Historic District Review Committee

Staff Report Addendum May 17, 2010

CAPP 2010-0002 Madison: New Residential Construction in the Waterford Historic District: PIN: 304-46-4671.

Photo 1: Typical brick jack arch on the Mahlon Schooley House on Second Street in the Waterford Historic District.

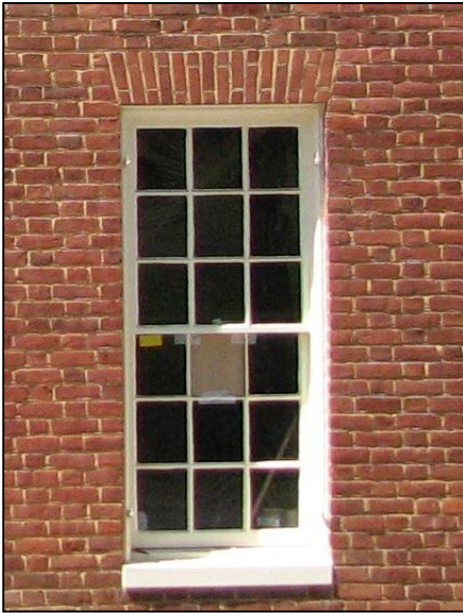
The applicant proposes flat jack arches above the windows constructed of a symmetrical row of vertical stretchers. This construction method does not follow historic precedent. Traditionally, jack arches have a trapezoidal shape created by cutting bricks to the correct shapes and sizes and have a height that is more than one stretcher length as shown in Photos 1 and 2 (Waterford Guidelines, Guidelines for New Construction: Materials and Textures, Text and Guideline 6, p. 75; Architectural Details and Decoration, Text and Guidelines 1 and 2, p. 73). **Jack arches that follow traditional building methods (trapezoidal shape, > one stretcher height, use of cut bricks) would meet the Guidelines.**

12. All windows in the main brick block will have flat trapezoidal jack arches across the top *constructed following traditional building techniques similar to photos 1 and 2 on page 2 in the Staff Report Addendum dated May 17, 2010. Attic windows in the brick main block will have a flat arch constructed of vertical header bricks.*

Photo 4: Brick corbelled cornice on the Dunne Residence. Also an example of rectangular vents in a boxed soffit.

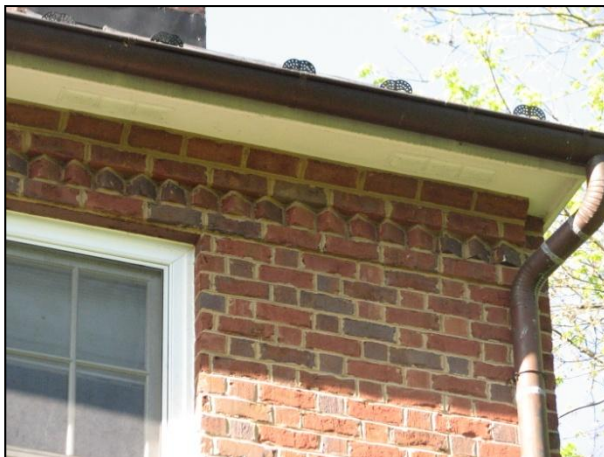
The proposed cornice continues to be a simple boxed eave with no adornment for the brick main block. The Guidelines recommend that applicants consider the use of a cornice, overhang, or parapet at the roofline of new construction based on historic precedents in the Waterford Historic District. This element should also relate to the overall style of the new dwelling. Wood is the most appropriate material, but substitute products may be approved (Waterford Guidelines, Guidelines for New Construction: Cornices, Overhangs, and Parapets, Guidelines 1 - 3, p. 65).

While the boxed eave with a board soffit and very simple treatment at the roof-wall junction is appropriate for the cementitious sided wing, rear ell, and bump out (if necessary), **the brick main block should have a more classical entablature with a cornice and architrave based on the proposed building's formality and material to meet the Guidelines for Architectural Details and Decoration.** Variations of corbelled brick or variations of scotia cove or crown moulding applied to the boxed soffit are cornice types that are found on historic brick homes in Waterford. One of the cornices depicted below should be selected and replicated for the façade of the main block (Photos 4, 5, 6, and 7). The dimensions should match exactly. Materials should be similar, i.e. brick corbelling should be brick, wood cornice should be painted wood or painted VERSATEX.

8. The cornice on the brick main block replicates the dimensions and materials of one of the options provided in *Photos 4-8 on pages 3 and 4 in the Staff Report Addendum dated May 17, 2010*.
